WEST ELEVATION

REVISIONS	
Architect	TBC
Engineer	HTS Engineers
Contract	Facade Survey, Sunlight House, Manchester, M3 3HP (24008)
Drawing Title	Facade Condition Survey - West Elevation
Date	15/04/2024
Scale	NTS
Drawn by	TH
Chk'd By	
Drawing No.	24008-PAYE-DR-004 rev P01

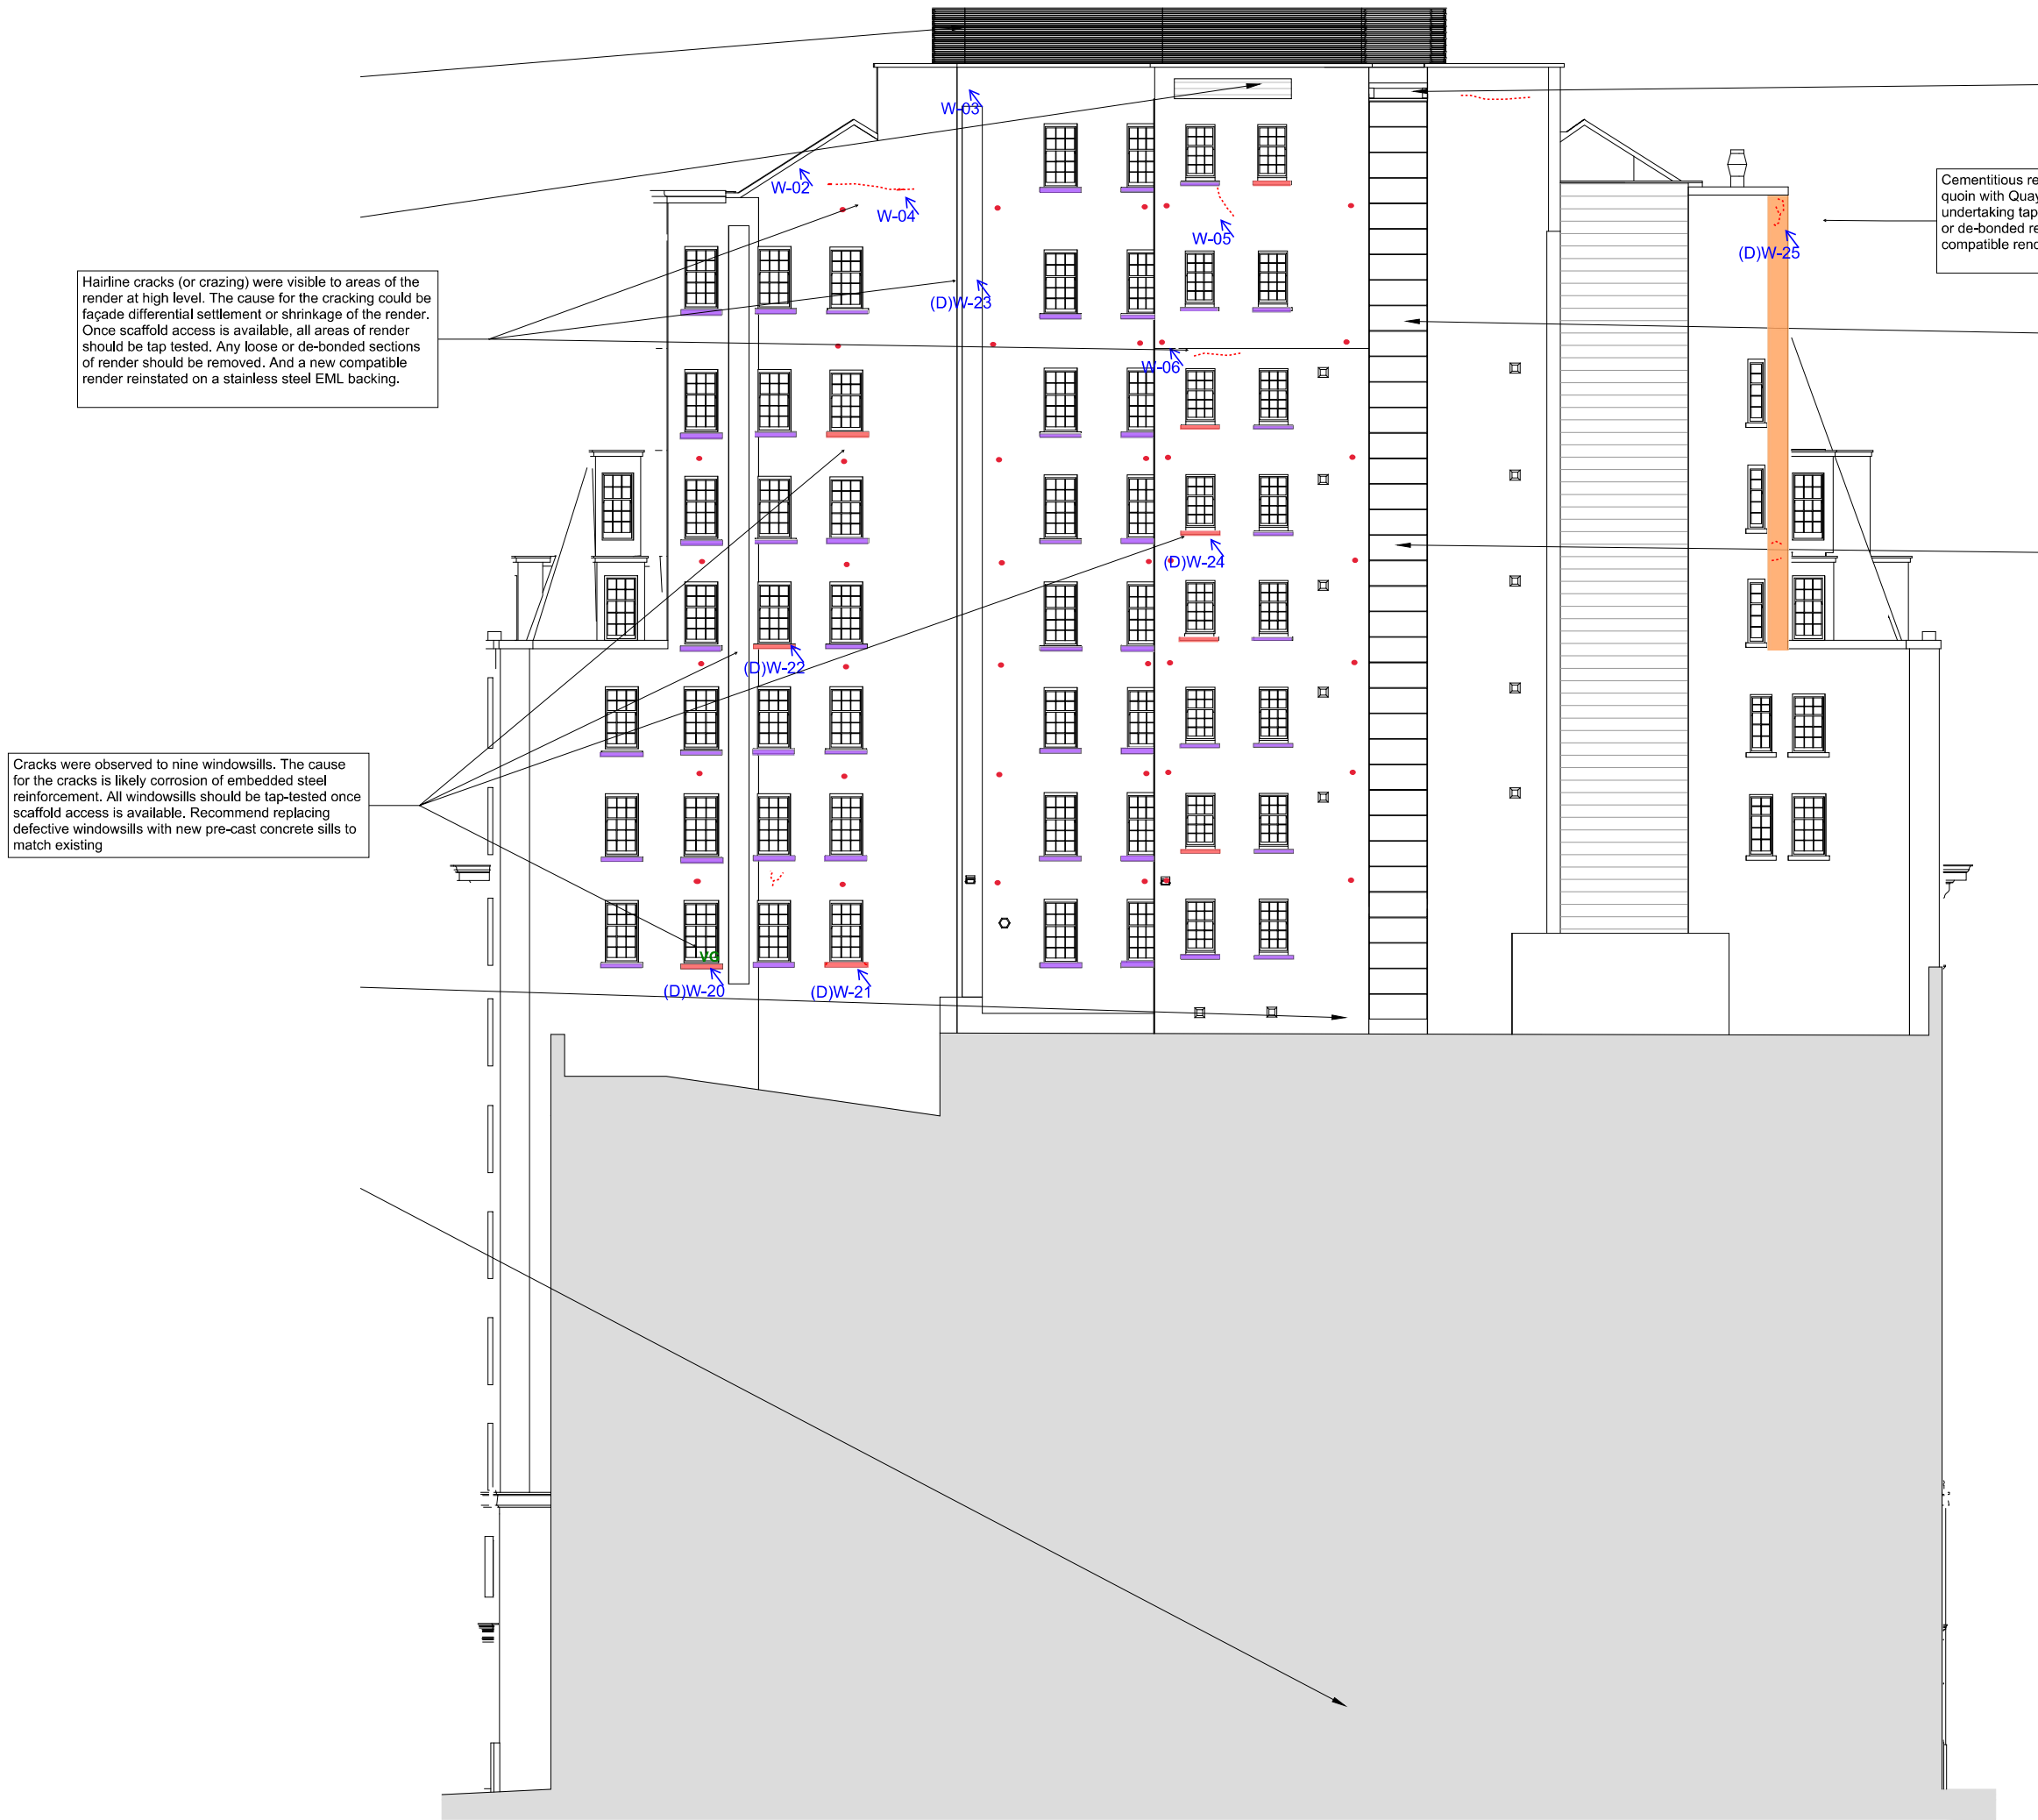
KEY	
	Viewpoint
	Fractures
	Hairline fractures
	PIN Recommend stainless steel pin repair (subject to structural engineers recommendation)
	DSP Displaced stone
	FR Friable stone. Recommend de-frassing stone to remove all loose material.
	Damaged stone (notable erosion, sections spalled). Recommend de-frass / indent repair / replacement unit.
	Existing render coat. Recommend tap testing to confirm well bonded.
	Redundant scaffold tie.
	FX Street furniture (e.g. CCTV, alarm etc.).
	Staining to masonry
	No access (excluded from the survey)
